CITY OF
West Linn
PLANNING MANAGER DECISION

FILE NO.: WRG-21-05/MISC-21-12

REQUEST: Request for a Flood Management Area (FMA) permit and Willamette and Tualatin River Protection (WRG) permit for a new gangway ramp to an existing private shared-use boat dock at 2115 and 2125 Windham Oaks Court.

RE: WRG-21-05 Windham Oaks Gangway Completeness Response

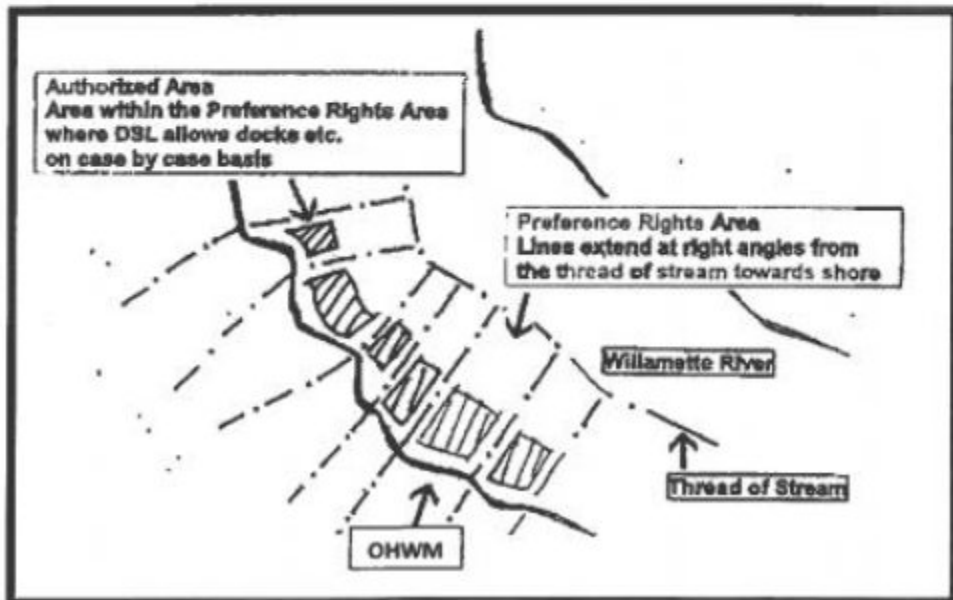
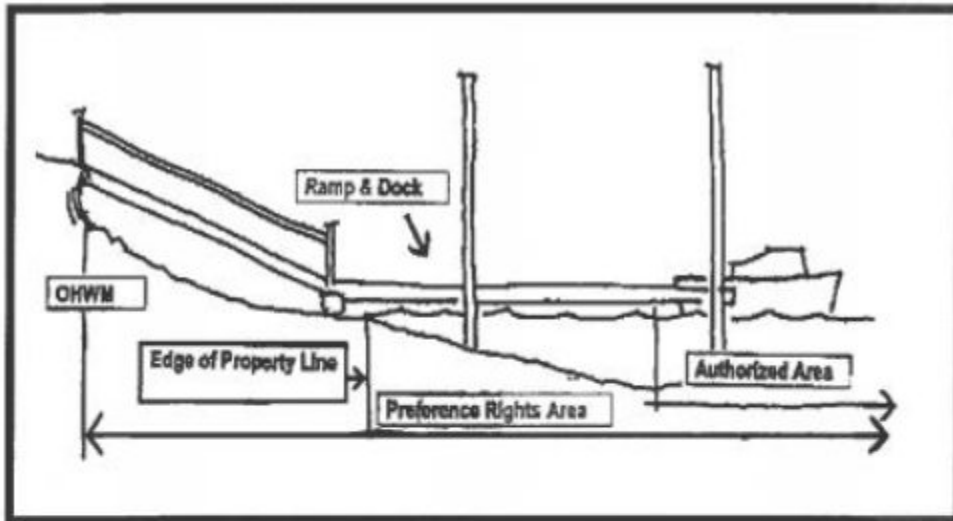
- a. The Plan sheets do not show the preference rights area or authorized area for the water surface structure. Indicate on the plans where the preference rights/authorized rights are located.
- b. It appears that a portion of the proposed gangway will be in the preference rights area; therefore, you will need to include a map that has been approved or acknowledged by DSL.

Response: No preference rights area pertains to the existing dock and a preference rights area map was never required due to the size of the existing and proposed water-dependent structures. As indicated by the email included as Attachment F, sent by Justin Russell- the Department of State Lands Proprietary Coordinator, the proposed gangway is authorized within the existing dock registration and does not require further authorization.

SHEET
P04

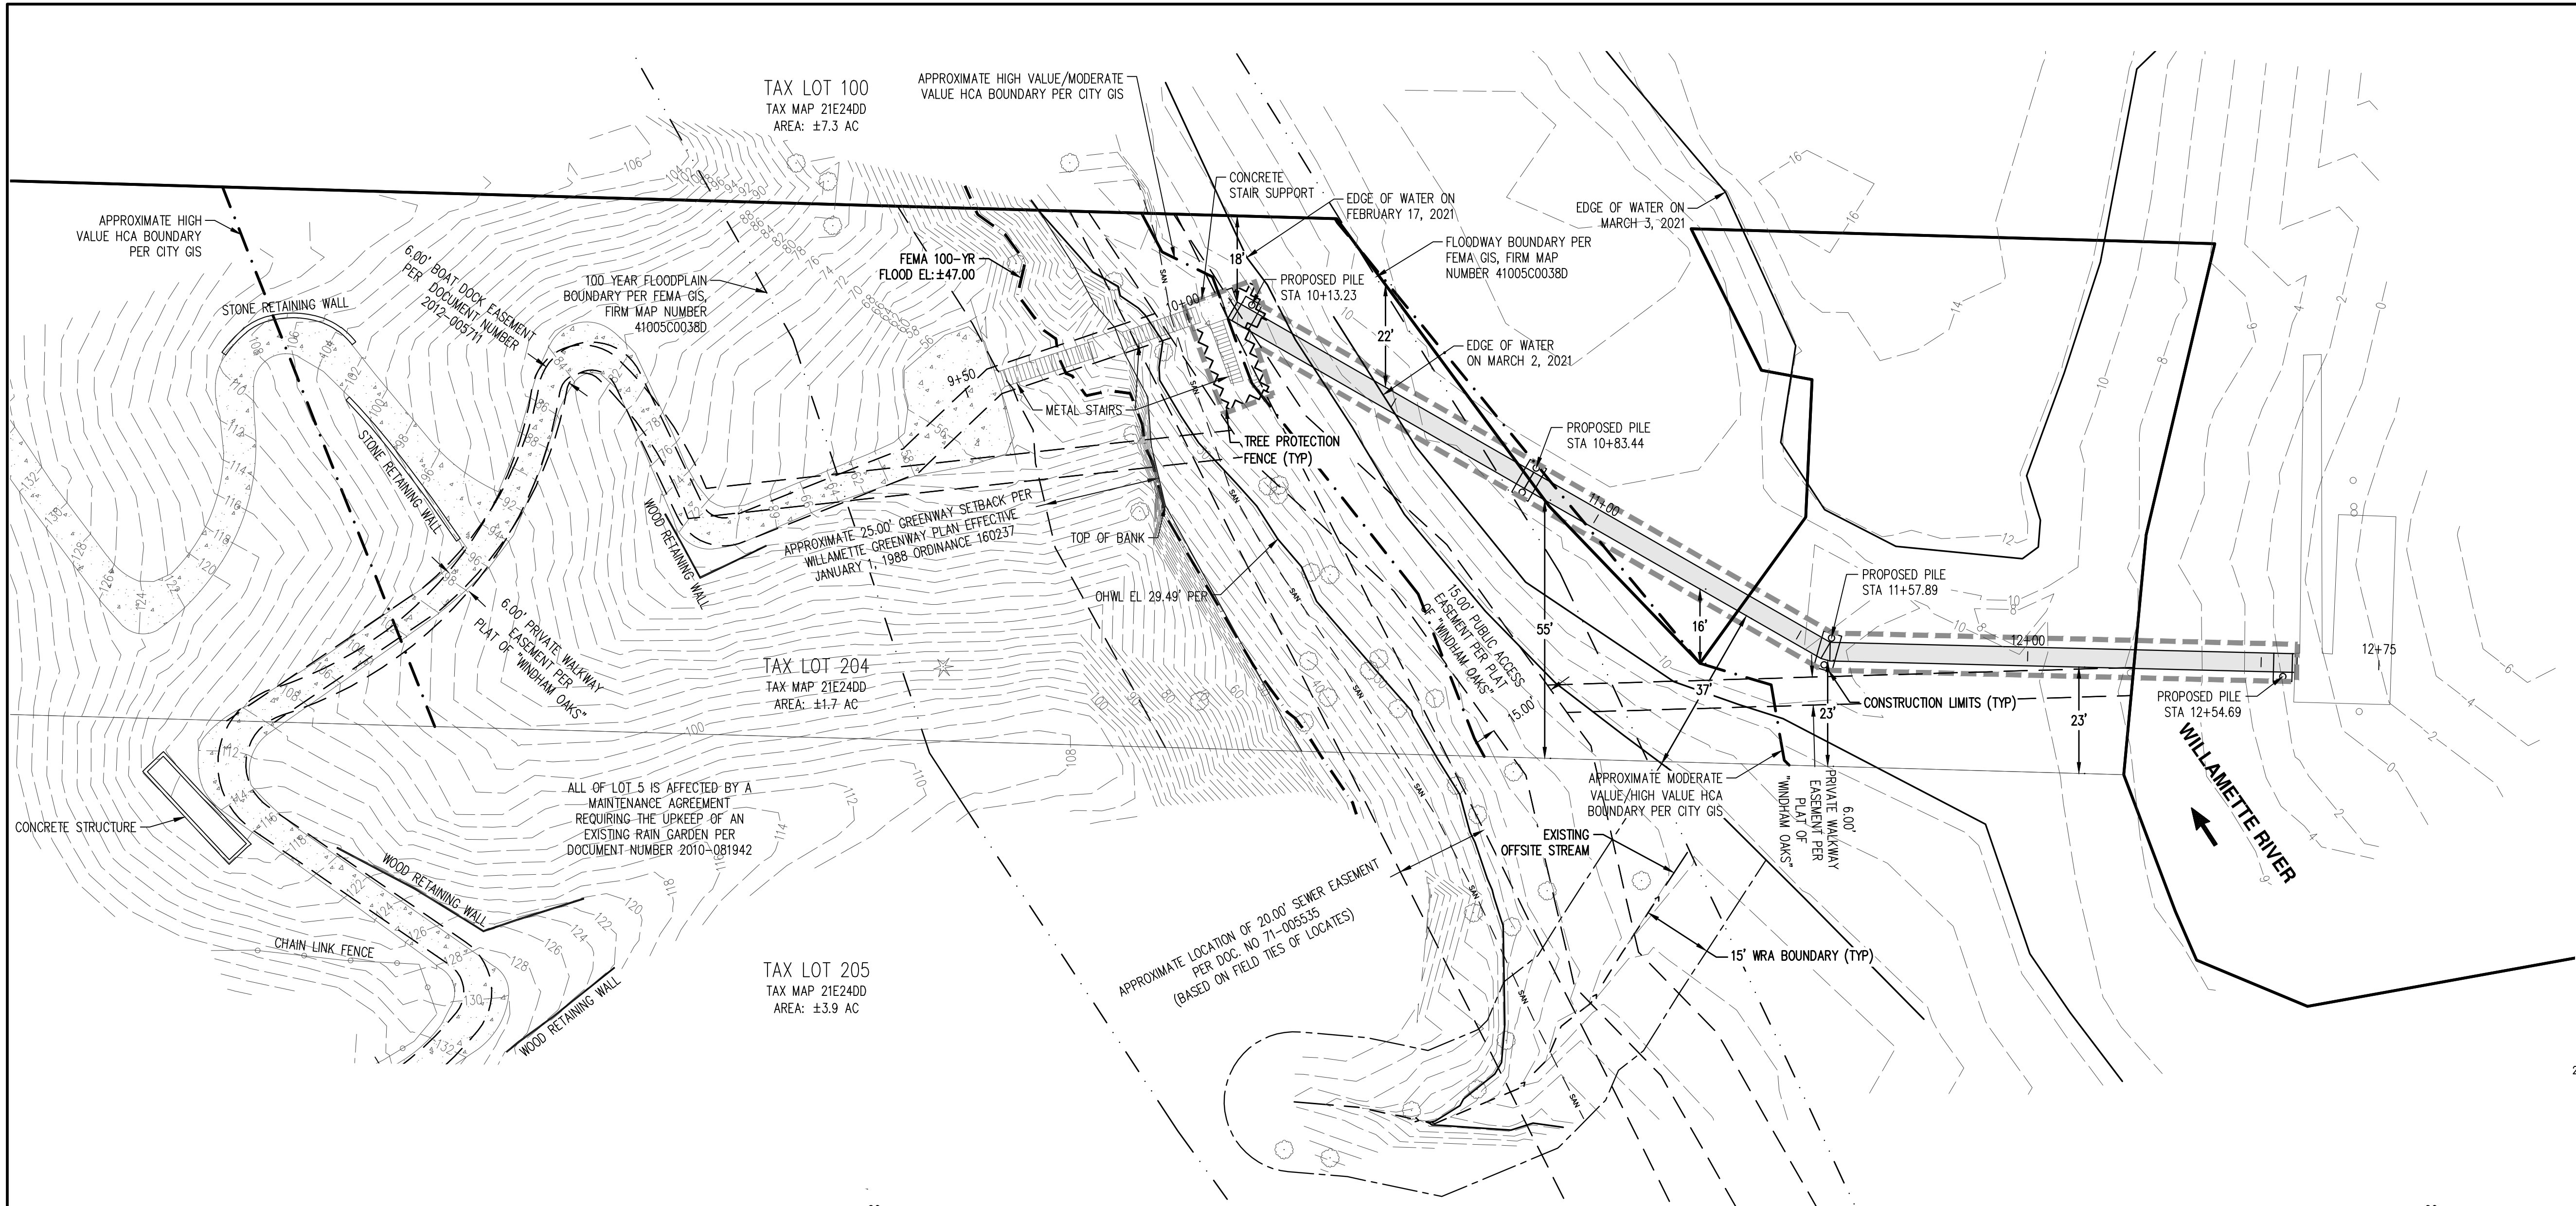
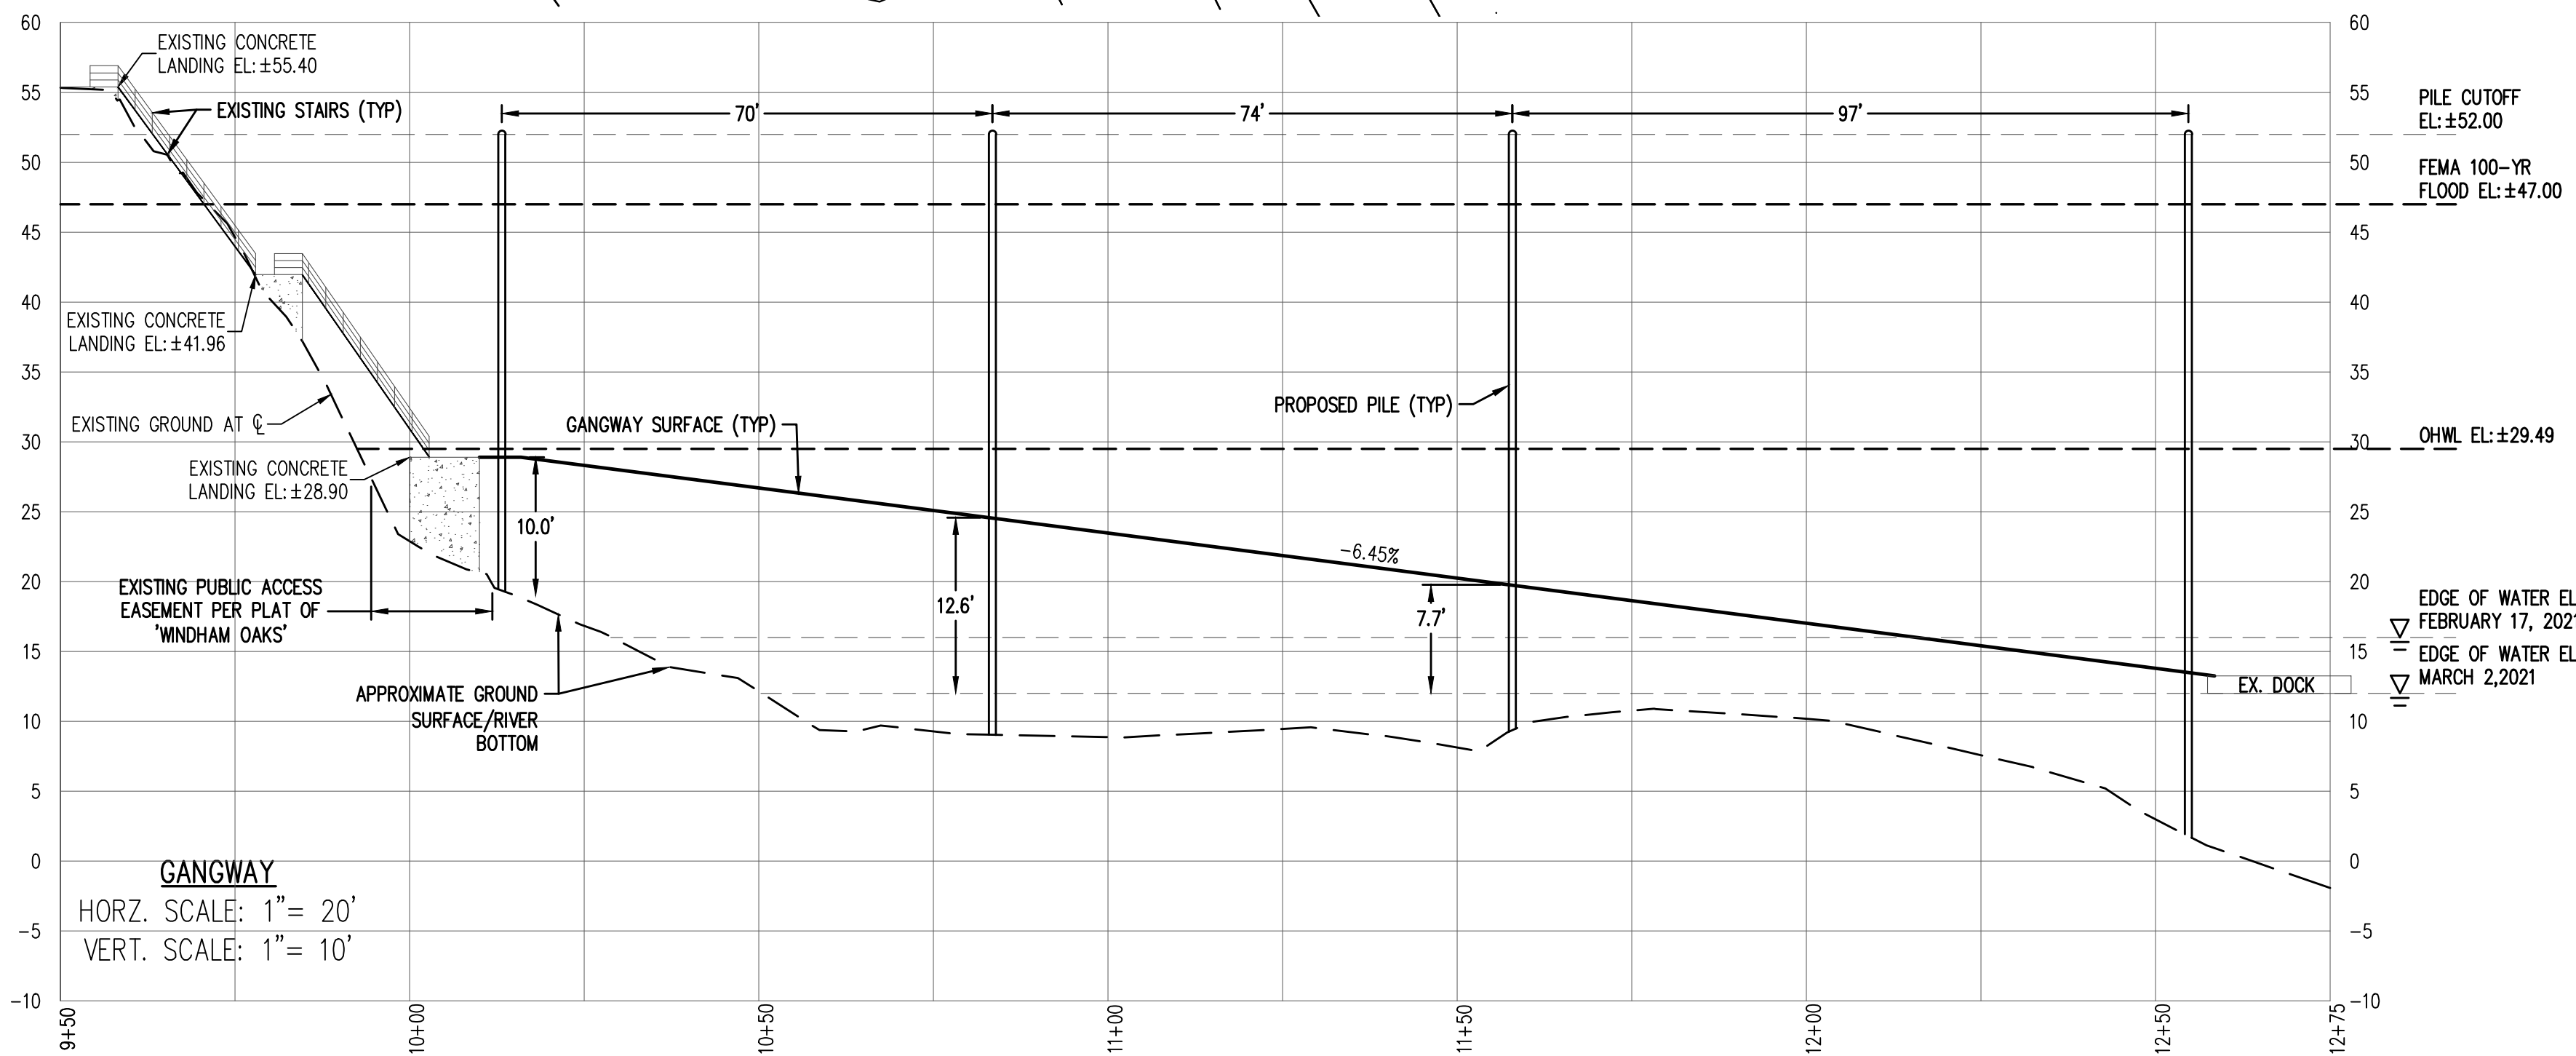
There is reference to Sheet P04, but there is no cut and fill shown on the plans. Please label the areas for cut and fill on the plans. Is there an equal amount of both cut and fill?

Response: The proposal does not include areas of cut and fill. A letter, signed by a registered civil engineer, was included in the original application materials attesting to the fact that the project will not impact the Willamette River Floodway. The engineer's letter is included with this response package as Attachment E.
